SERVICE INFORMATION NO. SI20-040

ATA Code: 34
GARMIN Service Bulletin No. 0921 Rev. B

****MANDATORY****
SERVICE BULLETIN
NO.: 0921 Rev B

TO: All Garmin Aviation Service Centers
DATE: July 13, 2009
SUBJECT: SL30, SL40, GNS 480 (CNX80) Comm Radio Spurious Emissions

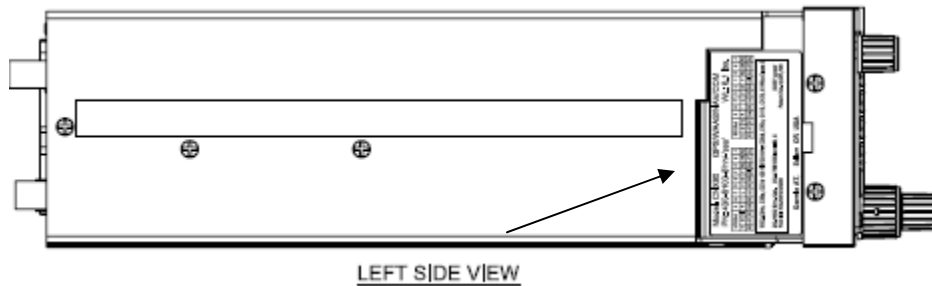
To identify the mod level of a GNS 480 (CNX80) unit:

Remove the unit and locate the nameplate on the left side of the unit. The hardware mod status is indicated in the block on the left side of the nameplate.

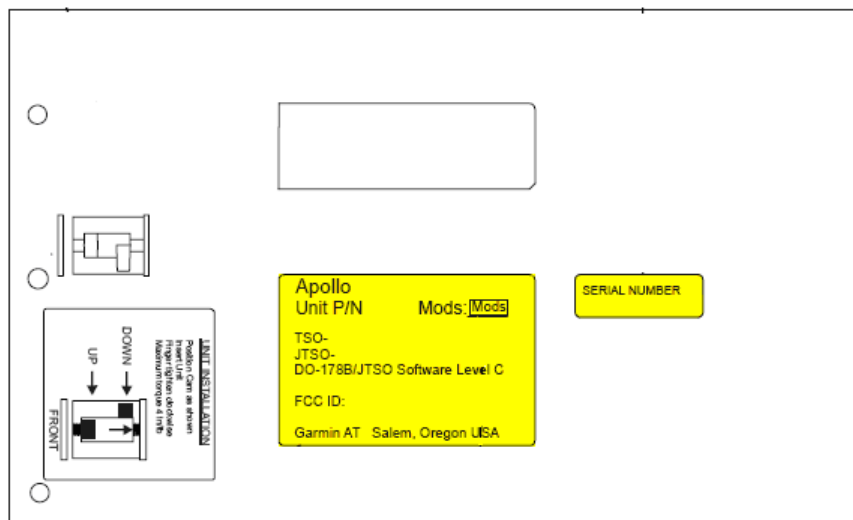
To identify the mod level of an SL30 or SL40 unit:

Remove the unit from the aircraft and locate the nameplate on the bottom side of the unit.

For SL30 and SL40 units: Installers are to make an entry in the aircraft maintenance records to indicate that Mod AE has been installed in accordance with SB 0921.
